Addendum 3

Project: Lathrop Fire Station 31

Rehabilitation

Project No: 757-01-20 Date: 12/10/2020

A9.01

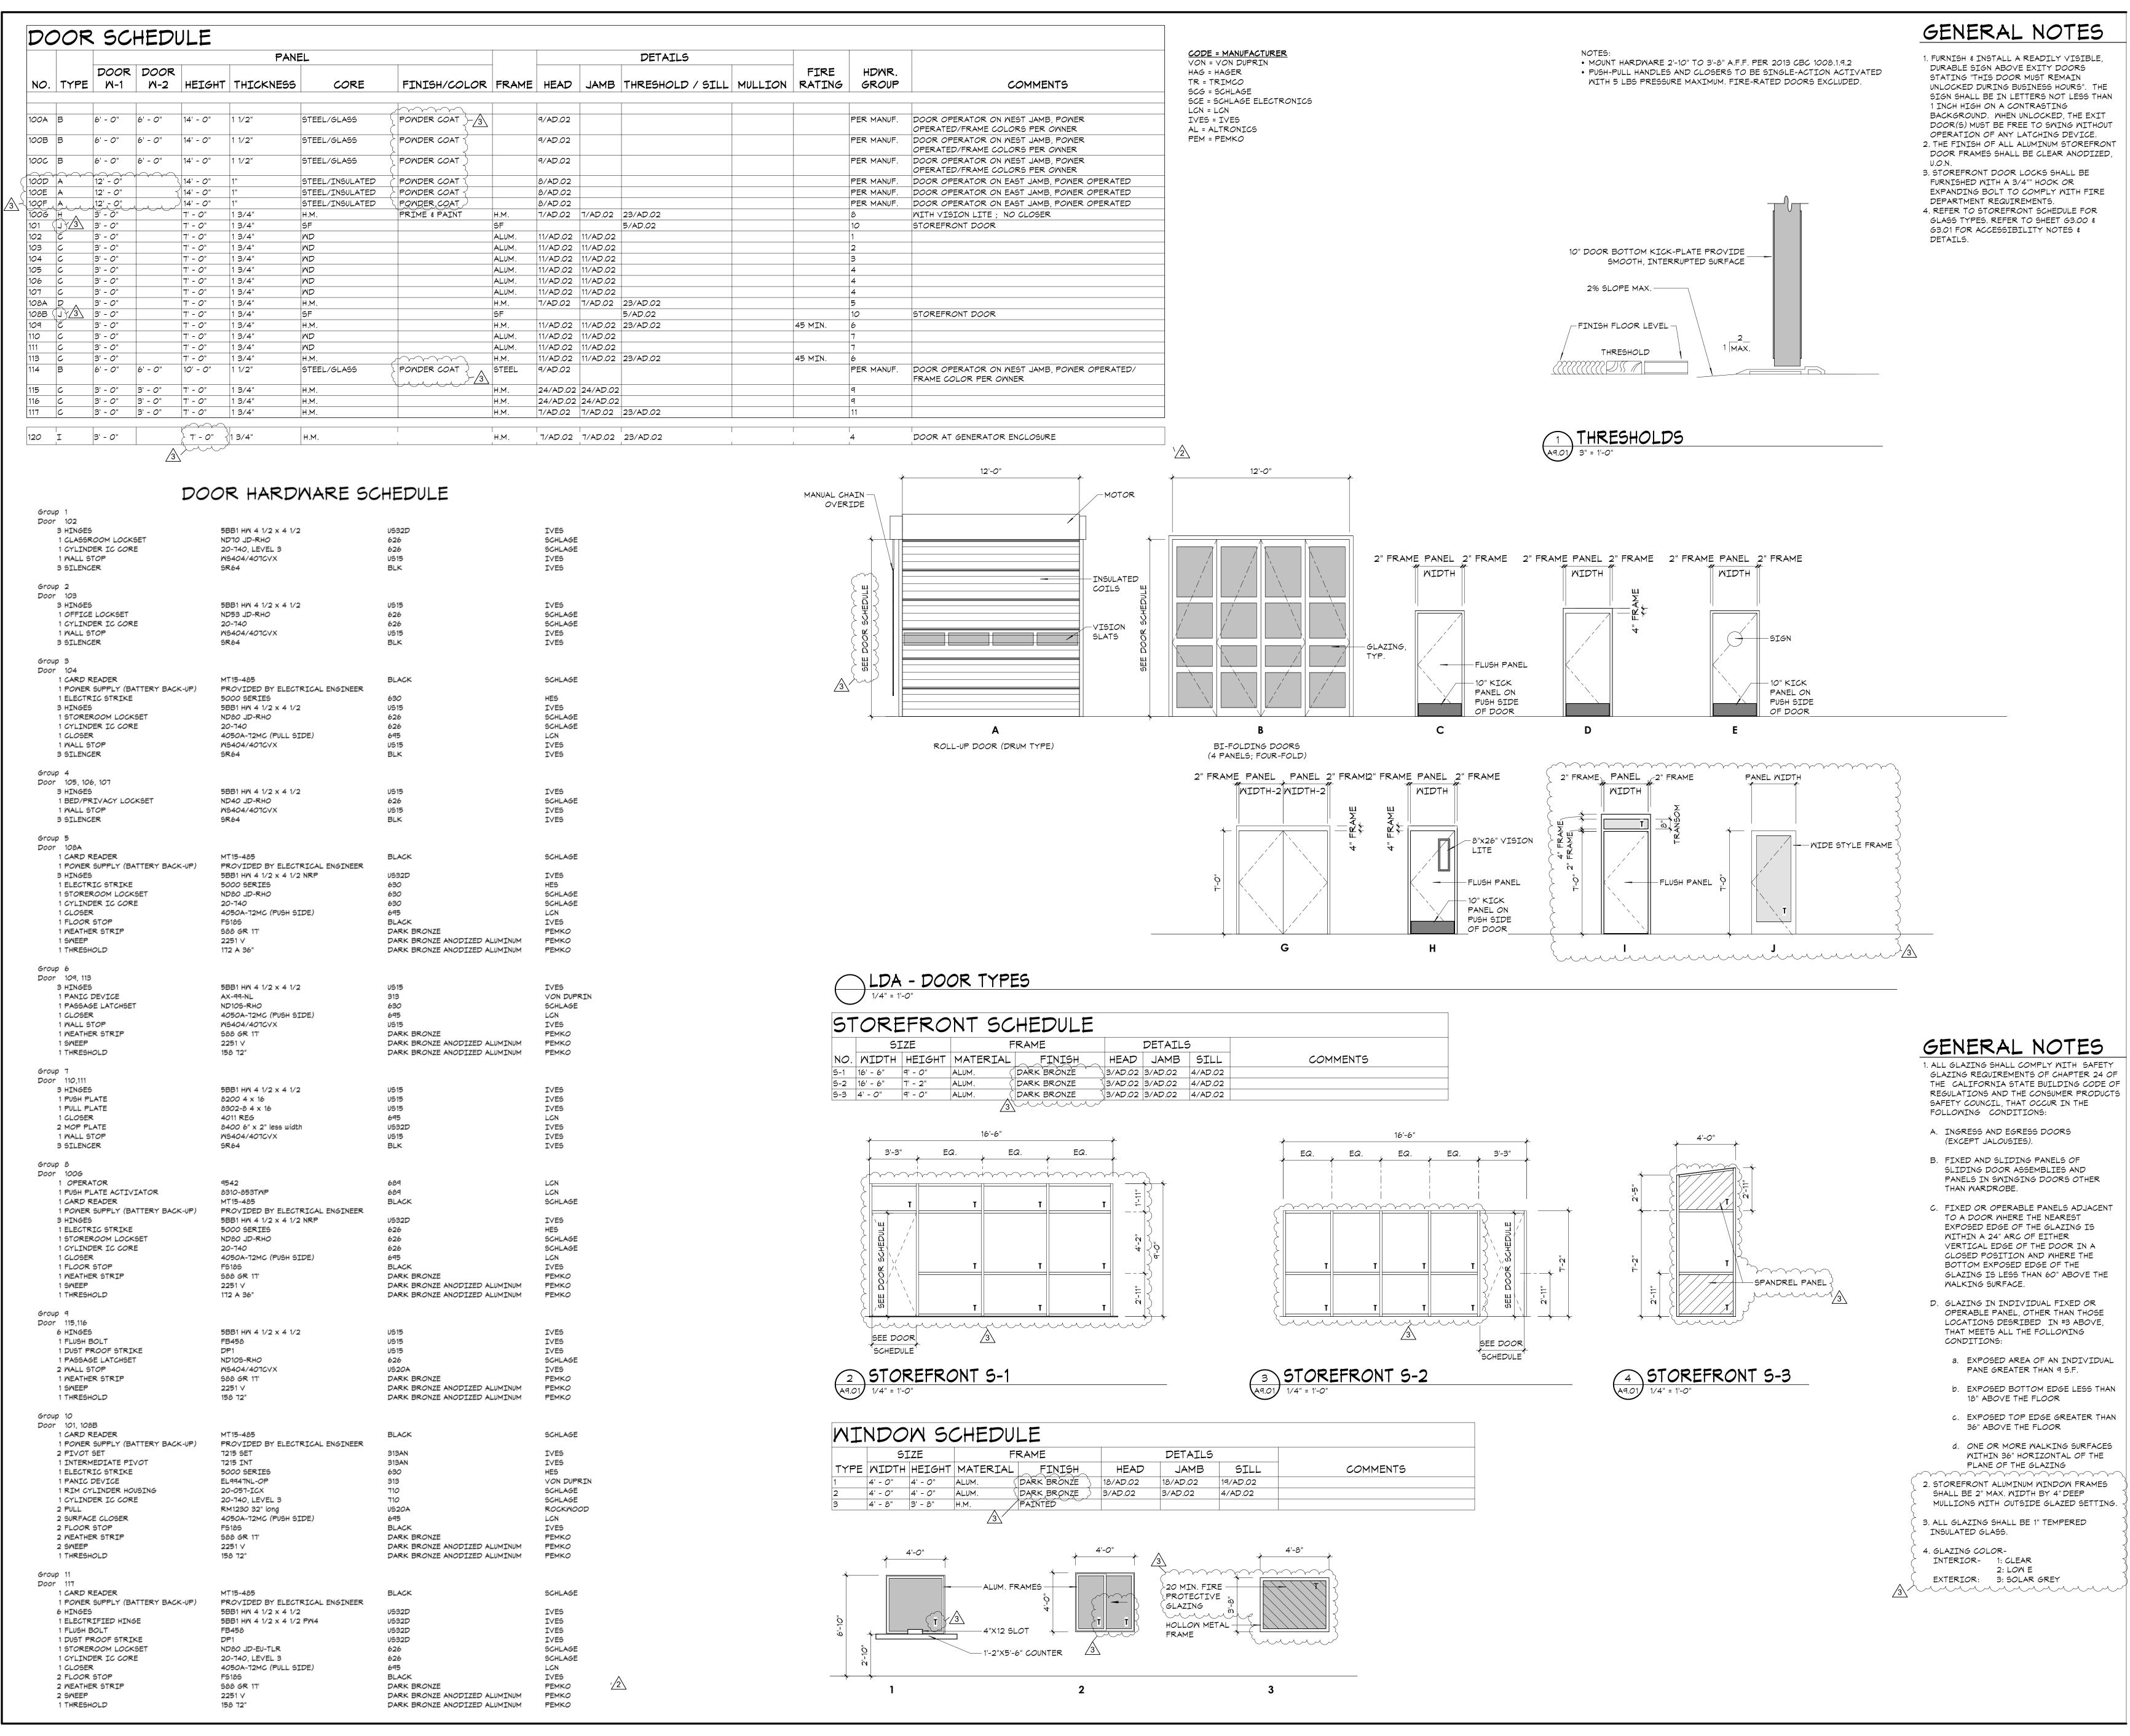
1. Project Plan Sheets have been revised (1 sheet total):

A9.01 Door Schedule
